## Product / Process Change Notification (PCN)

**PCN #:** PCN\_ConUSB2\_20240320

**Affected Series:** WR-USB;  
 61400413321  
 614004141221

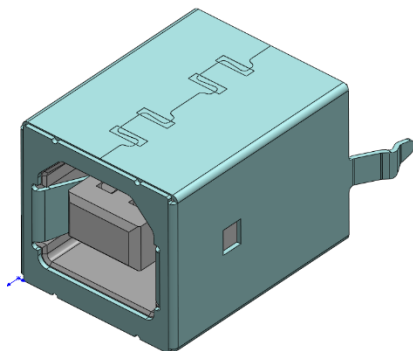
To improve the processability, Würth Elektronik will change the plating procedure from barrel plating to line plating. This modification result by a small change in appearance of the shielding.

### Detail of Change:

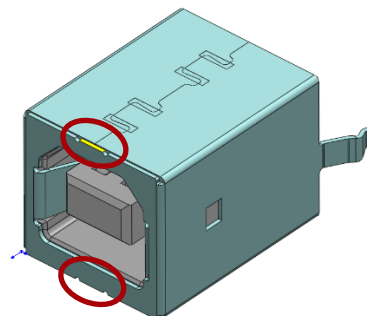
The shielding shape is changed in order to have a small cutting area (in yellow)
